SITE: WHITETAIL RIDGE PH. 4

CIVIC ADDRESS:  
128 FRANK FISHER CRESCENT

**Re: Proposed Single Family Dwelling, 128 Frank Fisher Crescent, Lot # 128 White Tail Ridge,  
Almonte, Kollaard Associates File # 230020**

With regard to structural issues only, Kollaard Associates has reviewed the following drawings:

BASEMENT PLAN

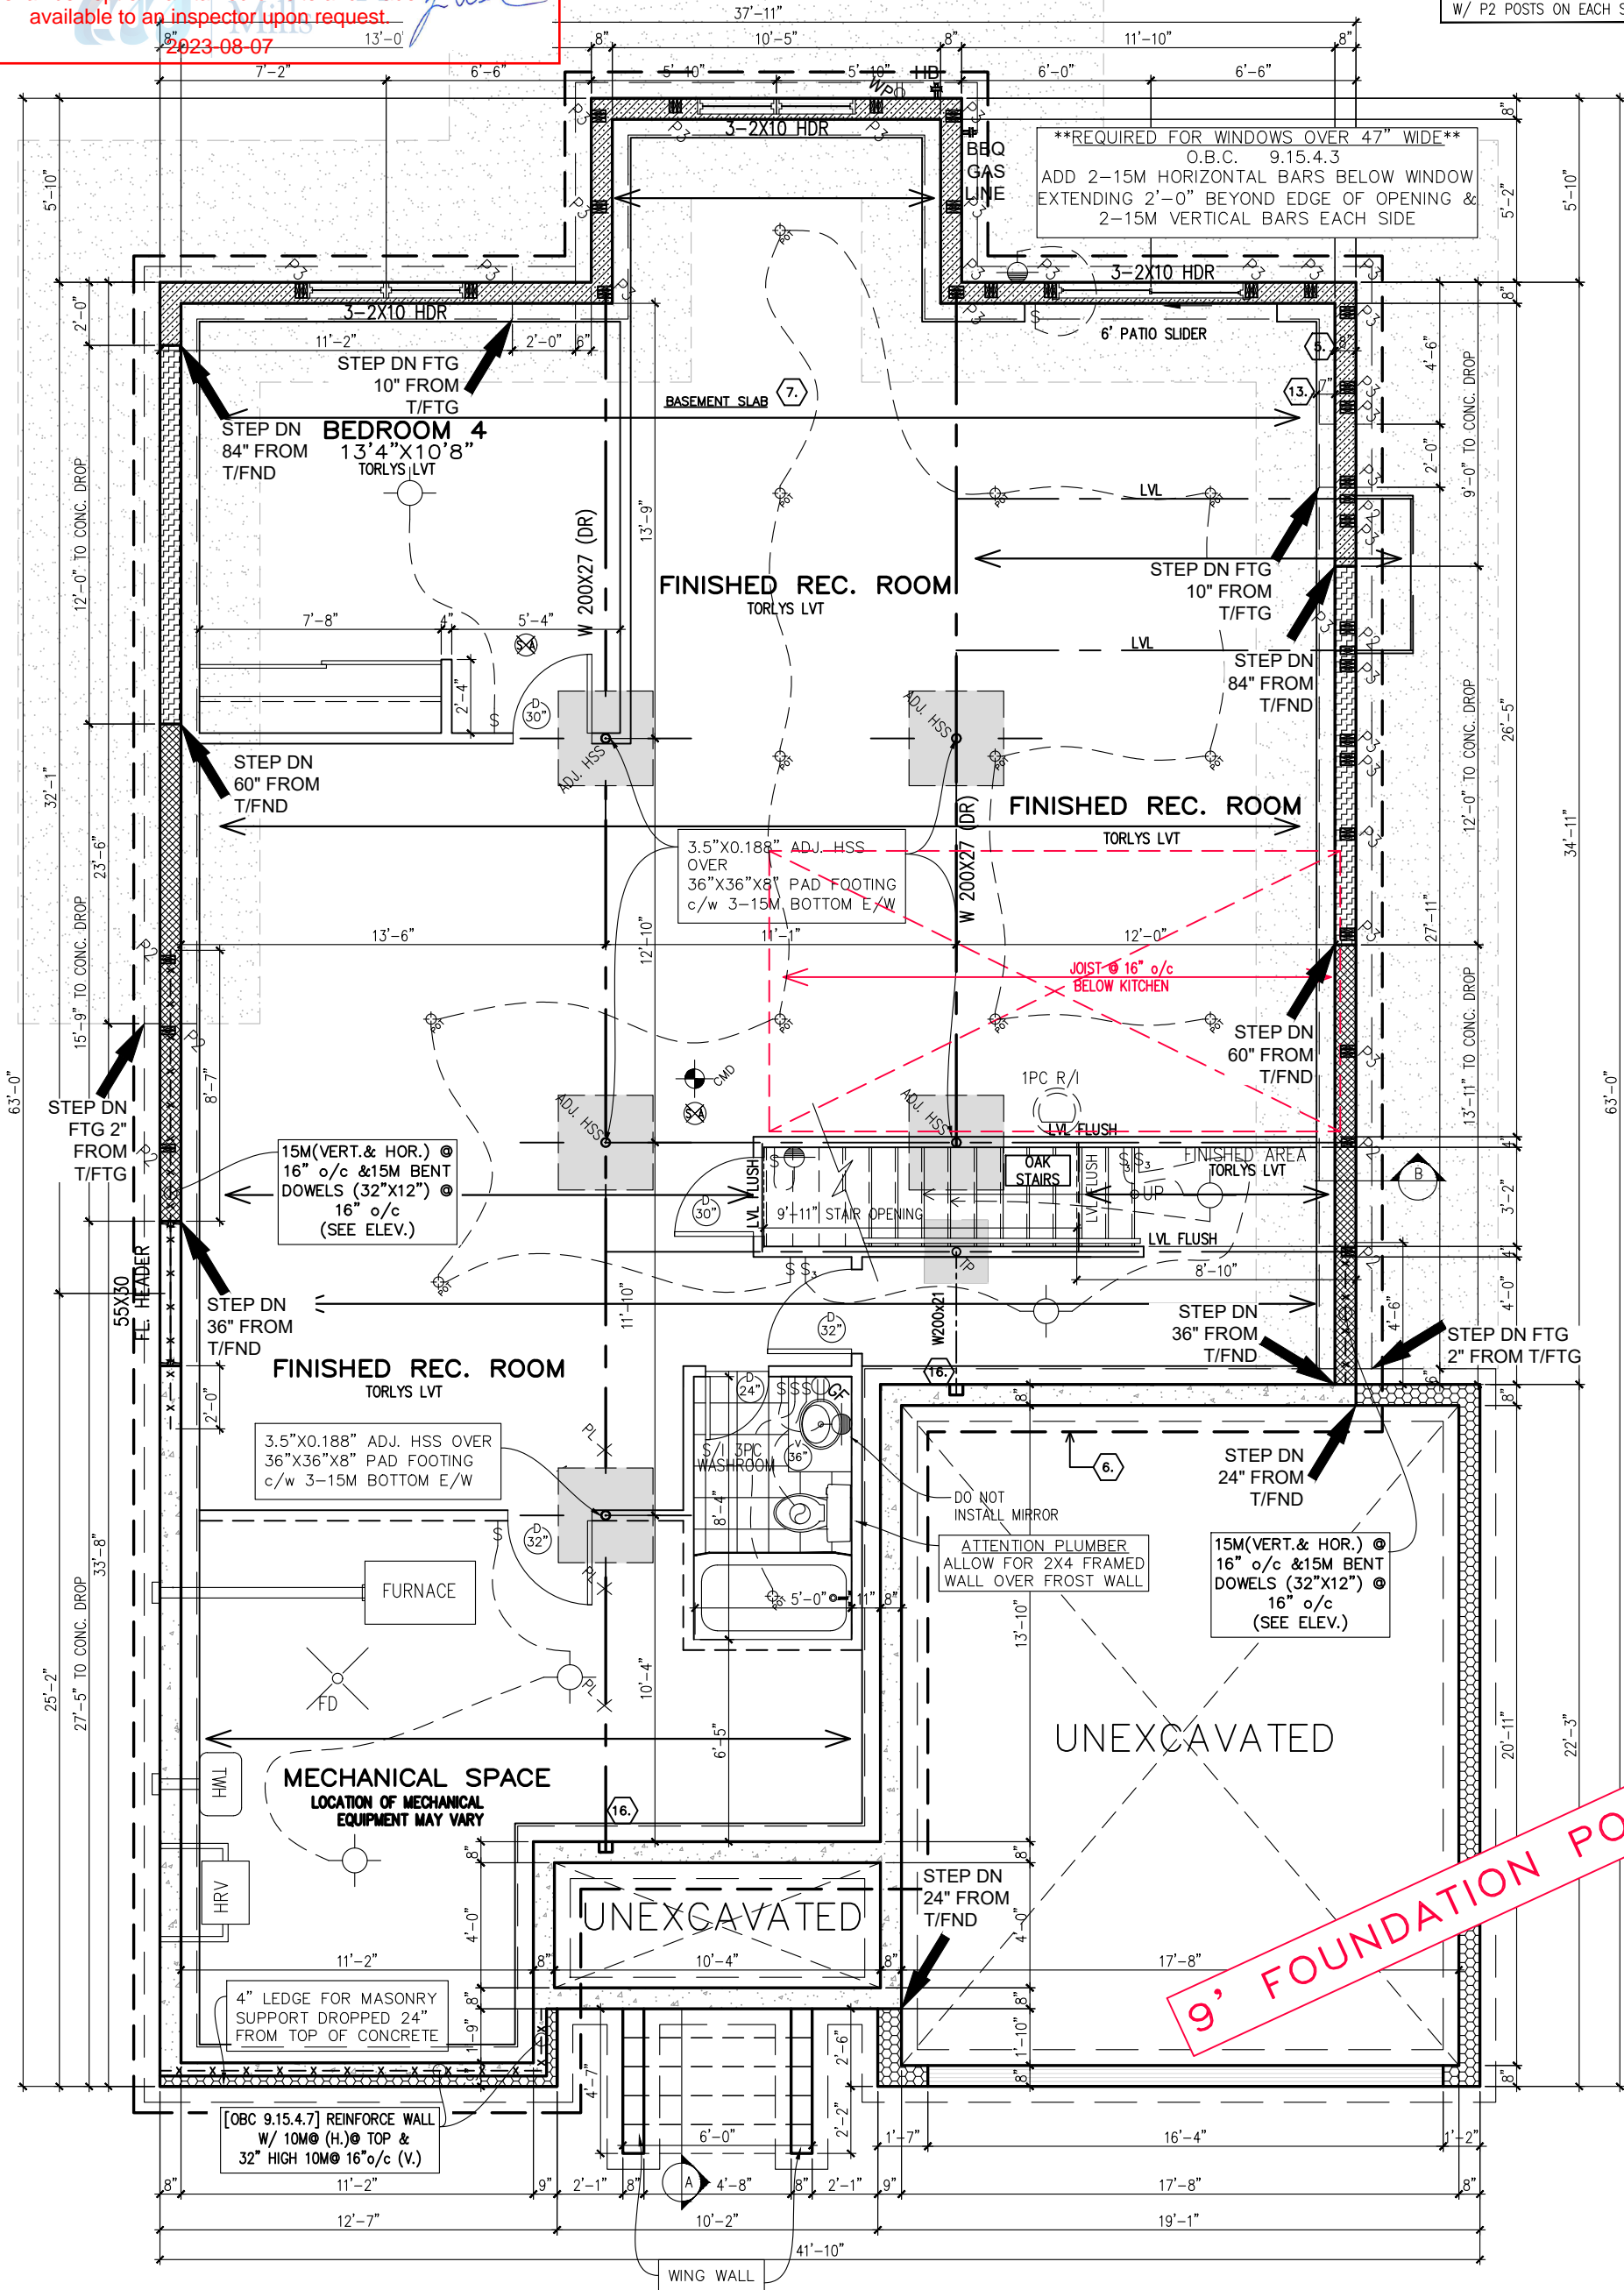
**Basement Plan – Pages # 2:**

5. It is the opinion of Kollaard Associates that the proposed steel beams, steel posts and built-up wood posts shown on Phoenix Homes Pages # 2 are adequate.

10. The strip footings and proposed interior pad footings shown on Phoenix Homes Page # 2 and noted on Phoenix Homes Page # 1 are adequate.
11. Floor joist design, flush LVL beams within the floor structure and LVL lintels are by the manufacturer. The posts supporting the flush LVL lintels shown on Phoenix Homes Pages # 2 are adequate.

12. If the flush LVL lintels are to be installed, the proposed 3-2x10 lintels specified on Phoenix Homes Pages # 2 may be neglected.

GROUND FLOOR

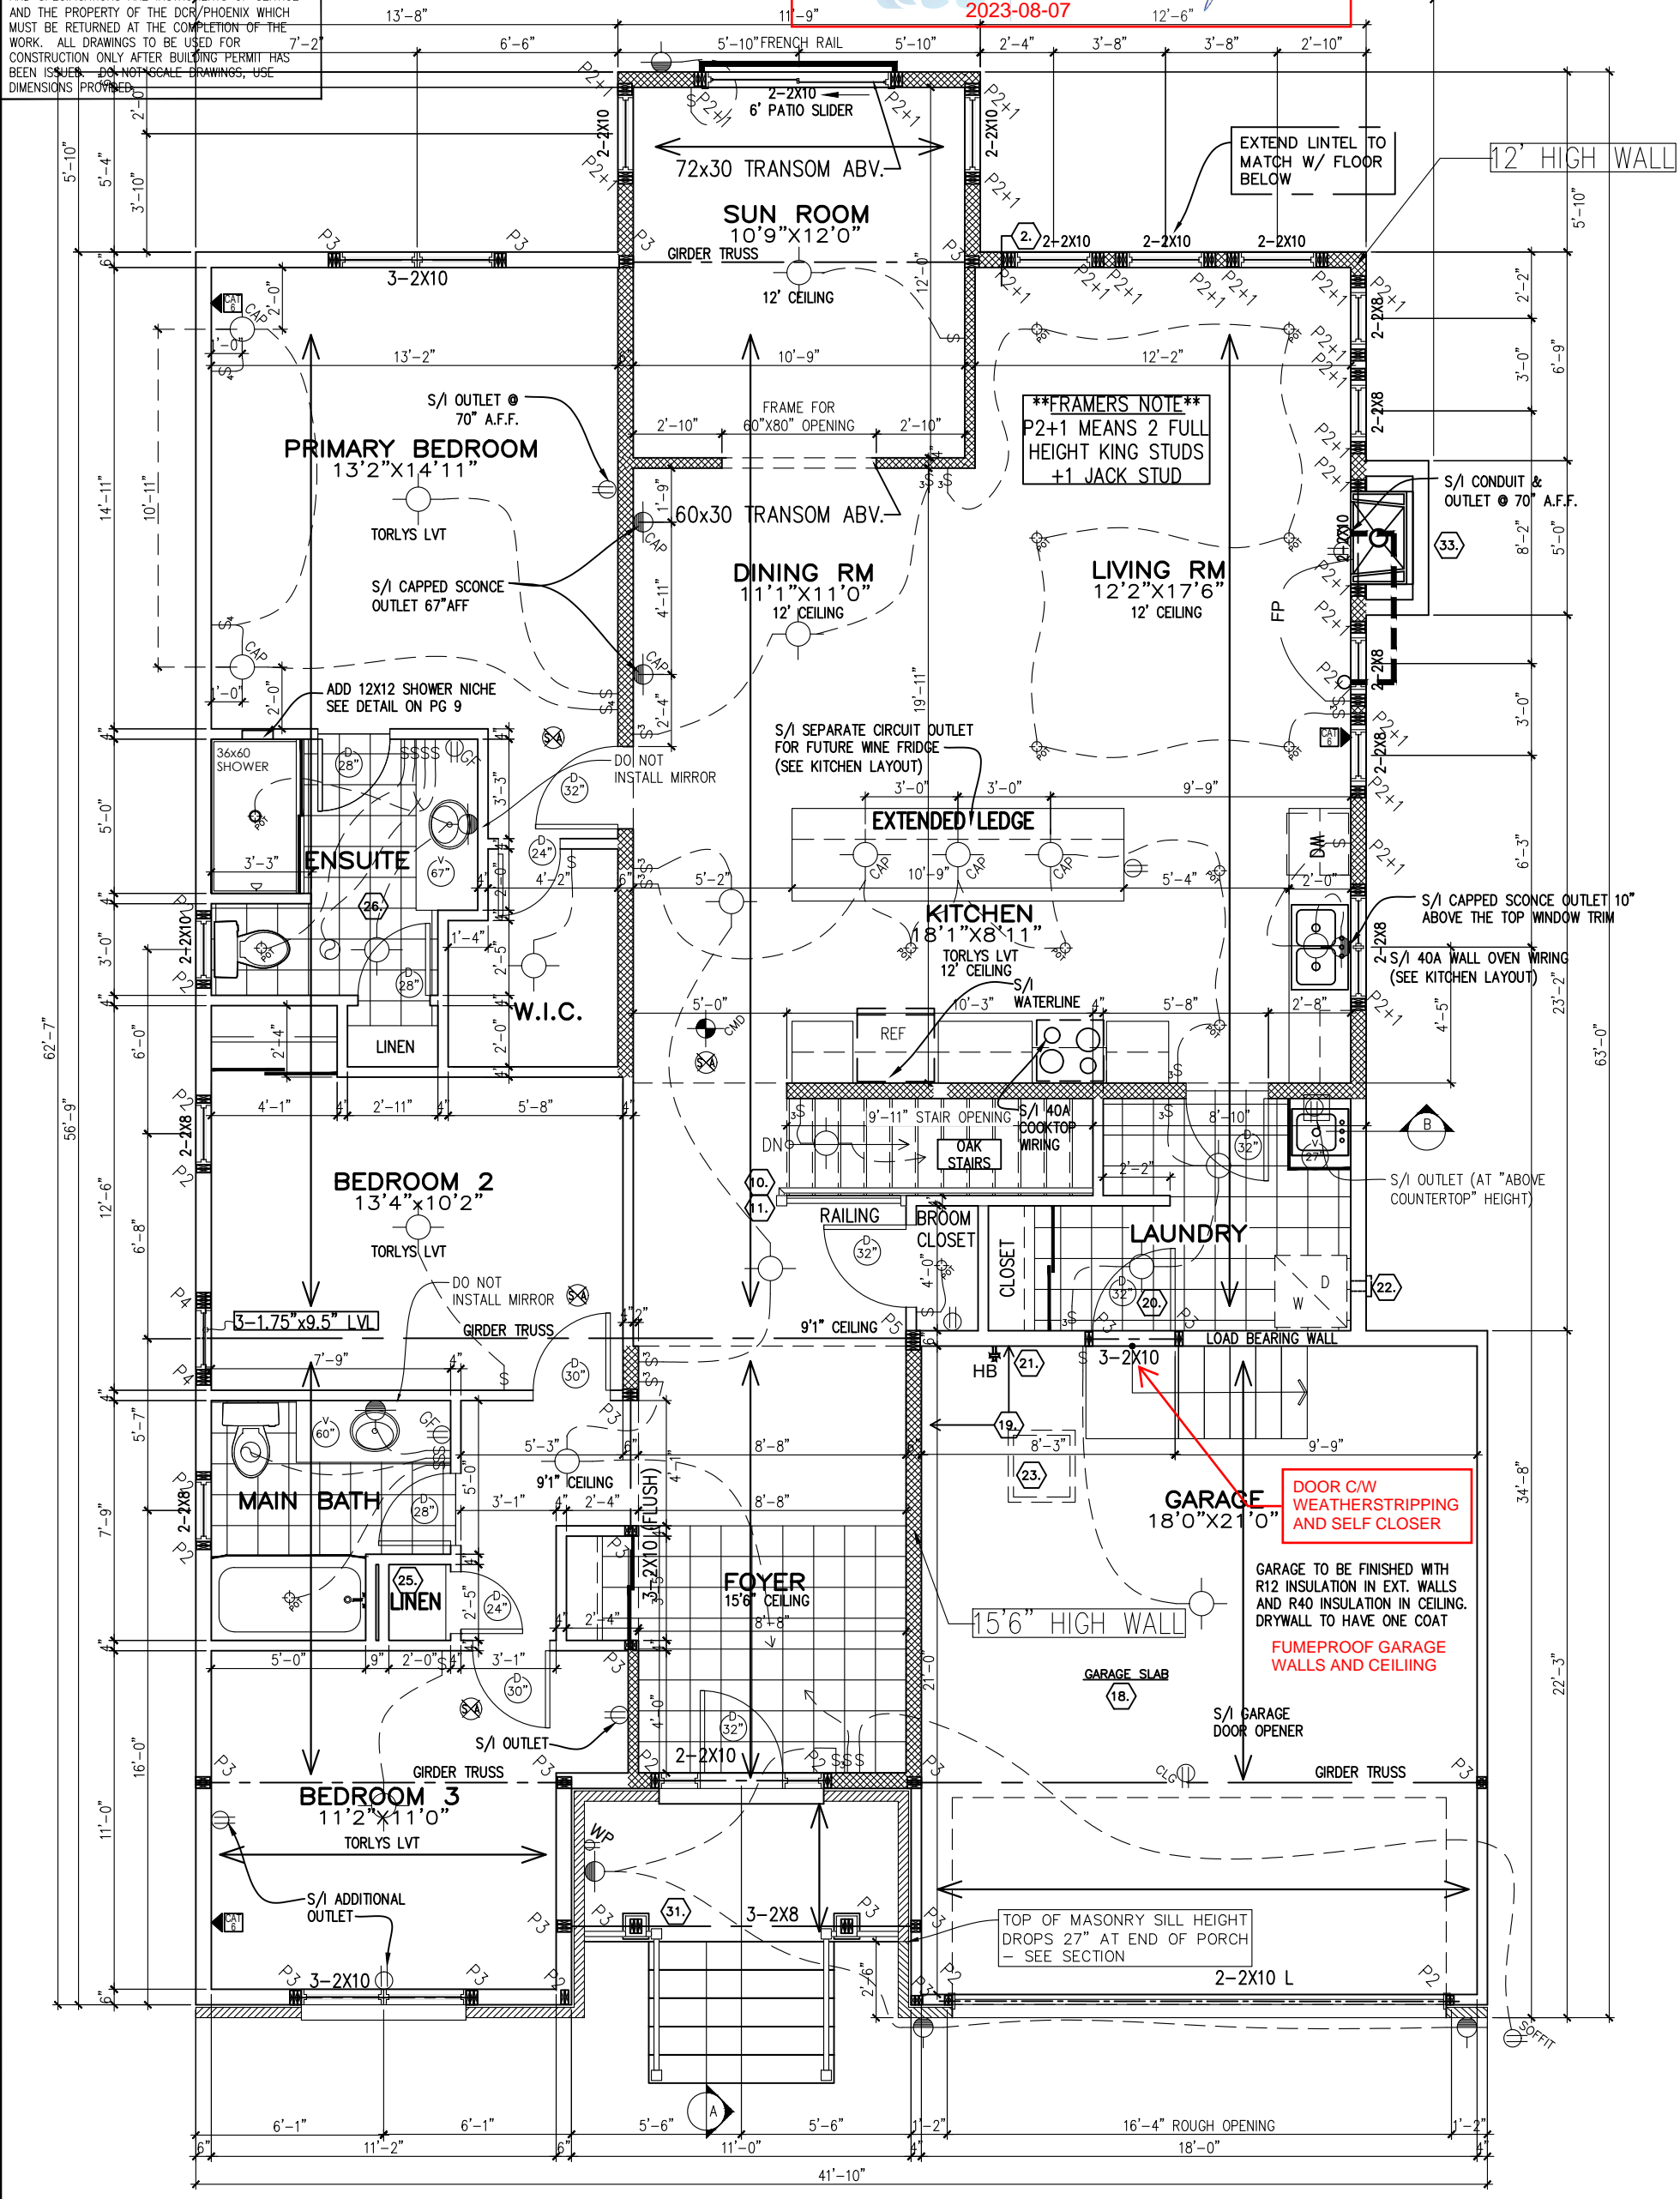
**Ground Floor Plan – Pages # 3:**

1. It is the opinion of Kollaard Associates that the proposed beams, lintels and supporting posts shown on Phoenix Homes Pages # 3 are adequate.
2. The proposed tall wall construction (including posts supporting lintels within the tall wall) noted on Phoenix Homes Pages # 1 is adequate.
3. Posts supporting girders may consist of built up 2x6 posts as indicated on Phoenix Homes Pages # 3 and are laterally supported by plywood or OSB sheathing (i.e. posts form part of sheathed exterior walls unless noted).
4. Truss design is by others.
